# UNITED STATES PATENT AND TRADEMARK OFFICE

<b>Office Action Summary</b>	<b>Application No.</b> 10/728,932	<b>Applicant(s)</b> KONUMA, TOSHIMITSU	
	<b>Examiner</b> Julie-Huyen L. Ngo	<b>Art Unit</b> 2871

## DETAILED ACTION

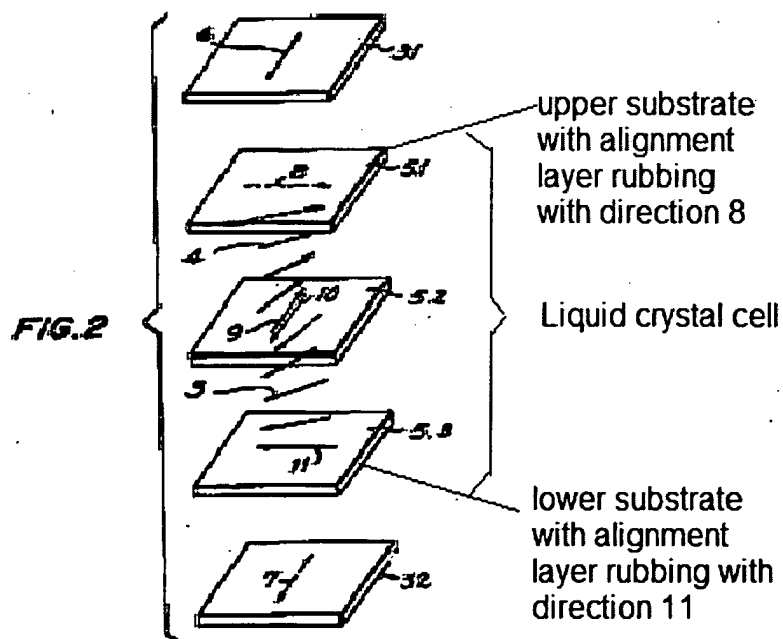
Banda does not teach or suggest a pair of orientation films on a pair of substrates having antiparallel orientation directions to each other, where the orientation films are in contact with a liquid crystal layer. Rather, for example, Banda discloses that a direction 10 on a bottom surface of the plate 5.2 is anti-parallel to a direction 9 on an upper surface of the plate 5.2 (column 4, lines 4-7; Figure 2).

Banda does teach or suggest a display cell comprising a plurality of liquid crystal layers 3&4 with a pair of orientation films on a pair of substrates (5.1 is upper substrate and 5.3 is lower substrate while 5.2 is intermediate plate) having antiparallel orientation directions to each other, where the orientation films are in contact with a liquid crystal layer. Banda discloses that a direction 11 on a bottom surface of the plate 5.3 is anti-parallel to a direction 8 on an upper surface of the plate 5.1 (column 3, line 54 to col. 4 line 38; Figure 2; reproduced below).

Applicants mistakenly point out one of the plural liquid crystal layers in the display cell to be a display cell. Banda uses a display cell comprising plural liquid crystal layers for confining such layers must lead to an increase in the absorption of light in the device, so that the optimum viewing directions for all of the layers in a poly-layer device coincide (col. 3, lines 35-45).
